Campaign #2A46

SAFETY RECALL NOTICE

IMPORTANT SAFETY RECALL NOTICE
This Notice Applies to Your Motorcycle VIN: XXXXXXXXXXXXXXXXX

Change Of Ownership/Address
Suzuki Genuine Accessory
Backrest Mounting Hardware Recall

Early Model Brackets
NO REPAIR NEEDED
Because it is equipped with two 75mm and two 95mm mounting bolts.

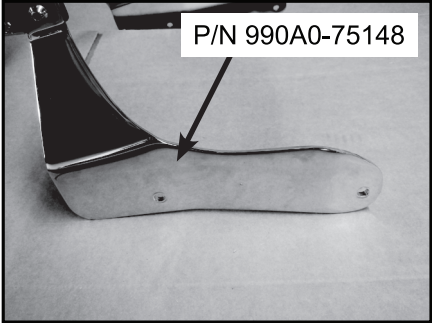
If the motorcycle is equipped with early model backrest mounting brackets with cutouts as shown below, no action is needed.

Late Model Bracket
without saddlebag supports NEEDS REPAIR
Because it is equipped with incorrect four 110mm mounting bolts — these bolts must be replaced with correct 75mm (two) and 95mm (two) mounting bolts.

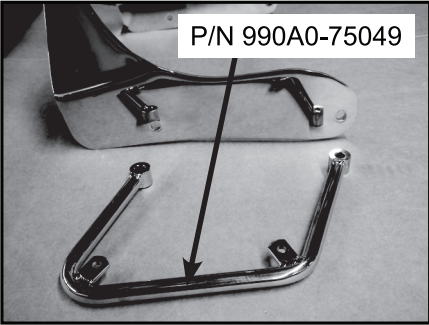
If the motorcycle is equipped with late model backrest mounting brackets without cutouts and it does NOT have saddlebag supports, the mounting bolts must be replaced.
